UNITED STATES
DEPARTMENT OF THE INTERIOR
BUREAU OF LAND MANAGEMENT

1. Type of Well <input checked="" type="checkbox"/> Oil Well <input type="checkbox"/> Gas Well <input type="checkbox"/> Other		5. Lease Serial No. NMNM81622
2. Name of Operator COG OPERATING LLC Contact: ABIGAIL MONTGOMERY E-Mail: Abbym@bcmmandassociates.com		6. If Indian, Allottee or Tribe Name
3a. Address 600 W ILLINOIS AVENUE MIDLAND, TX 79701	3b. Phone No. (include area code) Ph: 432-580-7161	7. If Unit or CA/Agreement, Name and/or No.
4. Location of Well (Footage, Sec., T., R., M., or Survey Description) Sec 30 T23S R30E SWSE 430FSL 1750FEL		8. Well Name and No. GOLD RUSH 30 FEDERAL 2
		9. API Well No. 30-015-29747-00-S1
		10. Field and Pool or Exploratory Area NASH DRAW
		11. County or Parish, State EDDY COUNTY, NM

Author:	MRM (7/2017)		
Well Name:	Gold Rush 30 Fed Well No. #2		
Field:	Nash Draw	API #:	30-015-29747
County:	Eddy	Prop #:	17628
State:	New Mexico	Zone:	Delaware
Spud Date:	8/16/1997	430' SL & 1750' FFL	
GL:	3070'	Sec 30 T23S R30E	
KB:	12'

Permanent Abandonment of Federal Wells
Conditions of Approval

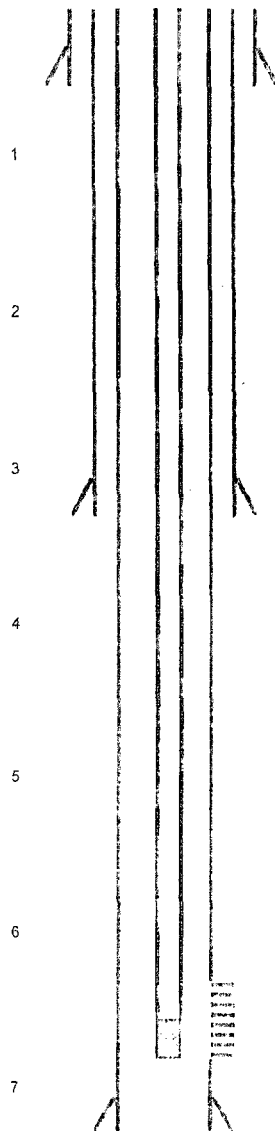
1. Set 5 1/2" CIBP @ 6585'. Circulate hole w/ MLF. Spot 25 sx cement @ 6585-6485'.
2. Spot 30 sx cement @ 5850-5690. (Brushy Canyon)
3. Spot 30 sx cement @ 4250-4090. (Cherry Canyon)
4. Cut & POH 5 1/2" csg. @ +/- 2820'.
5. Spot 155 sx cement @ 3325-2770'. Tag (Shoe, Bell Canyon)
6. Spot 650 sx cement @ 2770-300. Can be in stages.
7. Spot 45 sx @ 100-surface.
8. Cut off wellhead and weld on Dry Hole Marker.

** BLM REVISED ** BLM REVISED ** BLM REVISED ** BLM REVISED ** BLM REVISED **
